## PROPOSED AMENDMENTS - GARDEN

The changes outlined below relate to the pending planning application at 20 Eton Villas. Please also refer to the updated existing and proposed drawings for further information.

## PROPOSED AMENDMENTS - HOUSE

Proposed lower ground floor

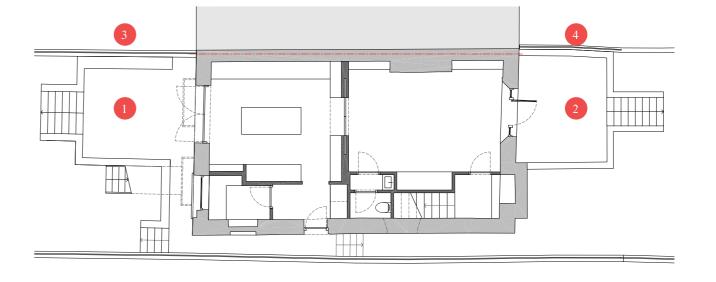
- 1. Existing front lightwell to be enlarged with the retaining wall to be brought forward. New steps shall be added to connect the patio to the front garden. The materials are to match the existing stone paving and brick and stucco walls.

- 2. Existing patio area to be enlarged with retaining wall to be moved into the garden. New steps are to be added to connect the larger patio area to the rear garden. The materials are to match the existing stone paving and brick walls.

- 3. Existing timber trellis to be added to the wall between No. 20 and No. 19 Eton Villas similar to the existing trellis on walls surrounding the rear garden.

- 4. Timber trellis to be replaced and raised to match the height of the existing hedge.
- 5. Existing brick piers on the street facing garden wall are to be reduced in height slightly. The overall appearance and materials of the piers is to remain as existing.

- 6. Existing brick pier on the street facing garden wall to be removed and be replaced by a low hedge.

Timber trellis to be added to top of existing brick garden wall.

Existing garden wall with timber trellis is to be renovated

Front elevation

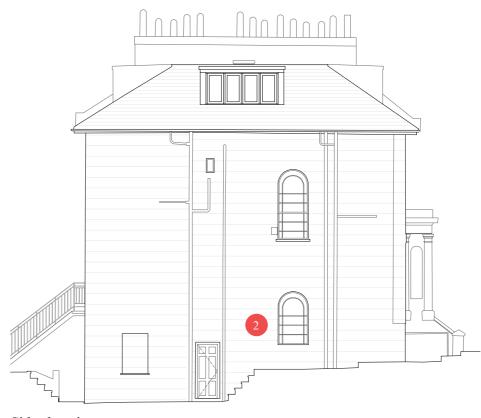
- 1. New timber framed door to be added to connect the lower ground floor to the lightwell patio in the front garden. The door is to be similar to the door in the same position at No. 19 Eton Villas, whilst the style and materials will be similar to the existing single glazed and timber framed window.
- 2. New single glazed timber framed sash window to be added to the side facade. The window shall match the style of the existing arched window above this, on the same side facade. The new arched window shall be in similar position to the original arched window in side facade, an example of this can be seen at No. 13 Eton Villas (image below).
